This is Field Safety Notice (FSN) acknowledgement that you received and understood the contents in pages 2 and 3.

Description of the problem

Modification of diagnostic ultrasound systems

Figure 1 Comparison of MPG values
(A: Spline trace, B: Continuous trace)

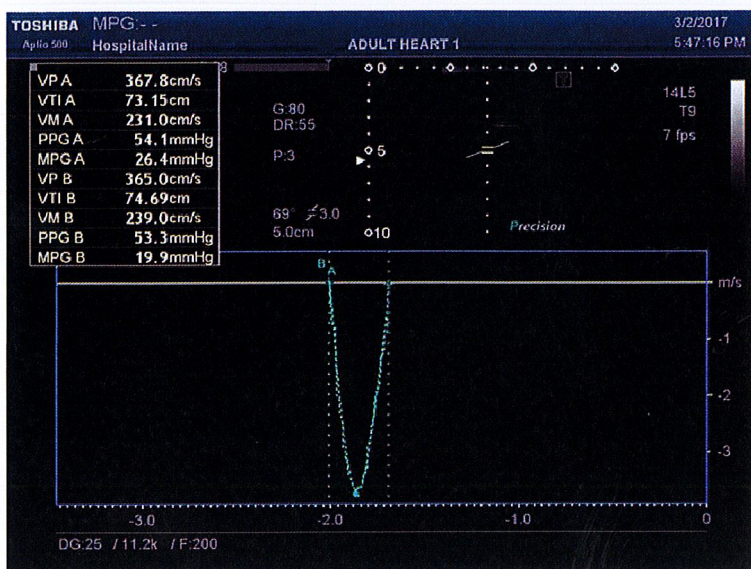
It has been reported that when velocity trace measurement is performed using Continuous Trace, the displayed MPG (mean pressure gradient) value may be as low as half that obtained by spline tracing in the diagnostic ultrasound system models and the ultrasound workstation models listed above. As a result, impaired function of the cardiac valves may be overlooked or normal cardiac valves may be incorrectly assessed.

The problem occurs when velocity trace measurement is performed on image data acquired in PW mode or CW mode, and Continuous Trace is used for tracing Doppler waveforms.

Modified software will be provided to correct the problem described above.

Until modification is performed, do not use Continuous Trace as the tracing method for velocity trace measurement when calculating the MPG (mean pressure gradient) value. Instead, use Range, Spline Trace, or Line Trace as the tracing method. Refer to the operation manual <Measurement volume> provided with the system for the procedures for changing the preset for the tracing method selected automatically at the start of measurement or for changing the tracing method during measurement.
